Our reference: 9393/BL
Date: 8th April 2022

Laystall St, Manchester - Roof Top Plant

The following provides our review of the roof top plant and how it could affect the hotel rooms adjacent and below in terms of noise.

Figure 2: Roof Detail

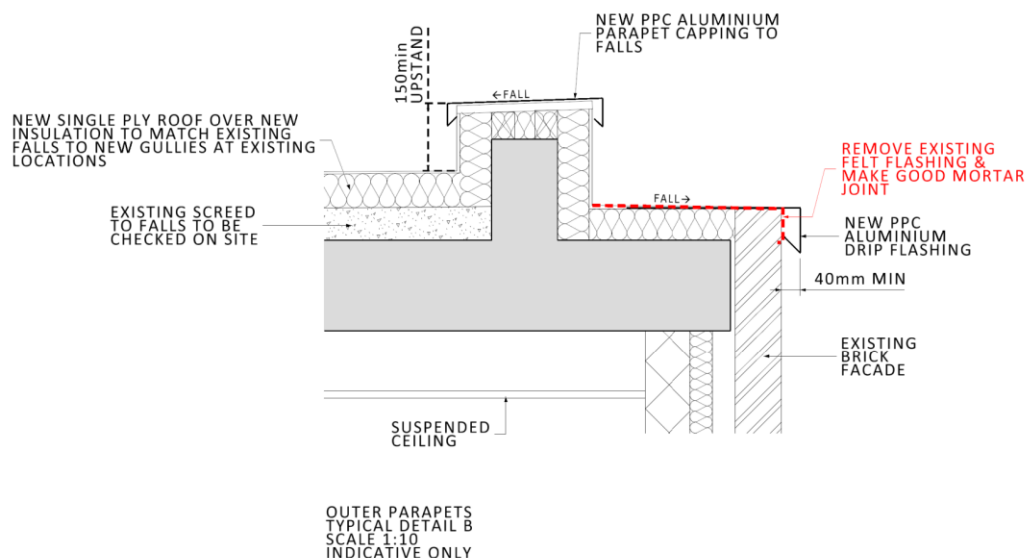
The roof we understand is concrete and at least 200mm thick with a plasterboard ceiling below. This should be confirmed by the client, but is based on the below detail:

Beneath the slab the ceiling should comprise of:

- 1 layer of 12.5mm Wallboard (mass at least 8 kg/m²).
- Metal frame creating 100mm cavity.
- 25mm of mineral wool in cavity.

This roof and ceiling construction is calculated to achieve the following sound reduction index:

The predicted level in the rooms below is NR24 which is within the criteria above, and therefore acceptable, subject to the ceiling upgrades.
